Catherine Fields Part Precinct

Riparian Assessment – Addendum 1

15th October 2013

Figure 1: Proposed substation location showing ILP, impacts to riparian corridor and proposed offset area

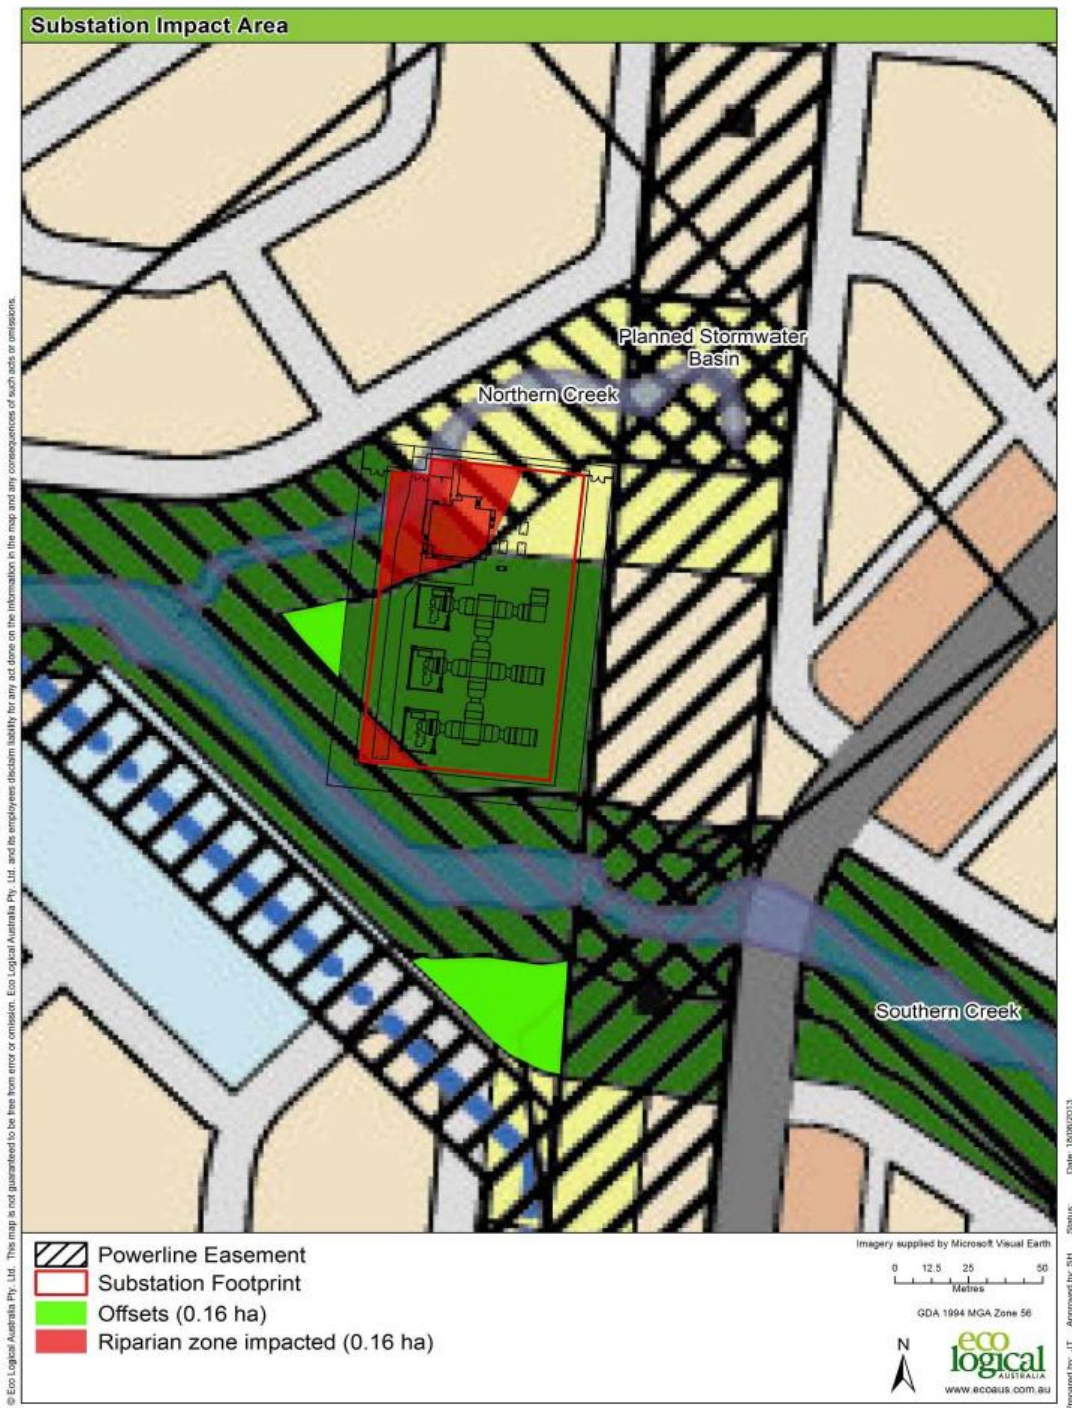
As discussed this letter provides you with a brief background of the project and the landholders proposal to locate the zone substation between two riparian areas.

During the post-exhibition detailed design stage, the landowner has put forward an option to move the precinct's substation from the location drafted in the exhibited draft ILP to a small parcel of land now being considered for urban development. This land is constrained by two creeks and an existing powerline easement and is considered by the landowner to be a more suitable location for the substation. **Figure 1** attached shows the proposed location of the substation and the two creeks, which have both been identified as Strahler 2nd Order streams. Discussions have been held with Endeavour Energy regarding the new proposed location and they have provided in principle support for the proposal.

The proposal will impact on 0.02ha of the southern riparian corridor and is proposed to be offset immediately adjacent to the substation.

The proposal will impact on 0.14ha of the northern riparian corridor. This is also proposed to be offset immediately adjacent to the substation. This impact will however result in a 'pinch point' of approximately 10 metres in total width. It has been confirmed by Brown Consulting (Greg Morgan pers. Comm.) that the width will be adequate to convey flood flows and will not reduce the hydraulic function of the creek.

In essence the proposals are considered to be minor and will be offset in the immediate vicinity. This approach is generally consistent with the 'averaging rule', however it is noted that the changes to the northern riparian corridor are within the inner 50%.

On a merit basis, the northern creek ends immediately upstream of the site. The creek through the site is ephemeral and where there is channelisation this has occurred through nick-point retreat. The channel is located with grazed a graze cow paddock and there is no native vegetation present. It is considered to be of very low environmental value.

The Office of Water has no objection for the proposed relocation of the electrical substation. Offset to the loss of any riparian areas resulted from the relocation may be required for any future integrated development.
